# Access Compliance Report

## Public Rights-of-Way

### (Curb Ramps)

Intersection ID: 10036710	Main Street: S_CLARKSON_ST	Cross Street: N/A	Location: S
ADA ID: 27A10484AD2F	Ramp Type: Perp	Initial Pass/Fail: Fail	Overall Compliance: No
Severity Score: 33.75			
Codes/Mitigation Info/Possible Solution		Field Measurements/Component Compliance

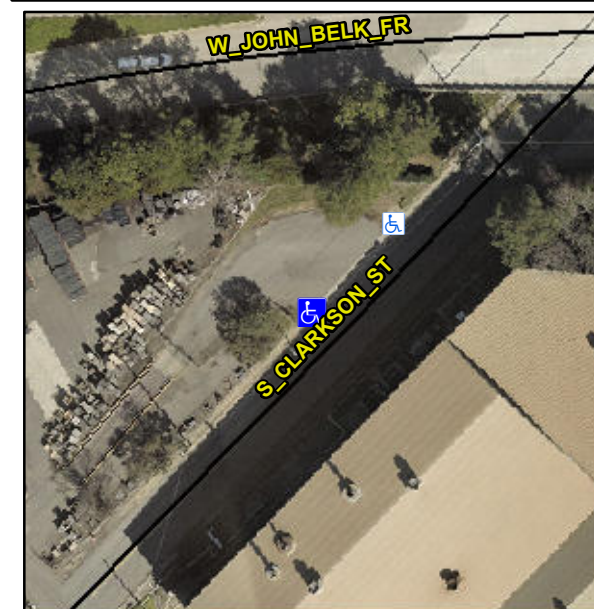
**Not Found, R304.5.1, R304.2.2**

Compliance	Description	Data	Compliance	Description	Data
N/A	Ramp Length (in)	56.0	No	Ramp Slope (%)	15.6
No	Ramp Width (in)	47.0	Yes	Ramp XSlope (%)	0.5
N/A	Flare Type LT	N/A	N/A	Flare Type RT	N/A
N/A	Flare Slope LT (%)	N/A	N/A	Flare Slope RT (%)	N/A
N/A	Flare Traversable LT?	N/A	N/A	Flare Traversable RT?	N/A
N/A	Landing Length (in)	N/A	N/A	DWS Provided?	N/A
N/A	Landing Width (in)	N/A	N/A	DWS Contrast?	N/A
N/A	Landing Slope (%)	N/A	N/A	DWS Length (in)	N/A
N/A	Landing X Slope (%)	N/A	N/A	DWS Full Width?	N/A
N/A	Landing Curb? (Y/N)	N/A	N/A	DWS Offset (in)	N/A
N/A	Shared Landing?	N/A			
N/A	Gutter Ponding?	N/A	N/A	Gutter Slope (%)	N/A
N/A	Gutter Lip Ht (in)	N/A	N/A	Gutter X Slope (%)	N/A
N/A	Painted X Walk1?	No	N/A	Painted X Walk2?	N/A
	X Walk 1 Direction	To NE		X Walk 2 Direction	N/A
N/A	X Walk 1 Width (in)	N/A	N/A	X Walk 2 Width (in)	N/A
	X Walk 1 Slope (%)	6.6		X Walk 2 Slope (%)	N/A
	X Walk 1 X Slope (%)	10.6		X Walk 2 X Slope (%)	N/A

**Remove & Replace Entire Ramp.**
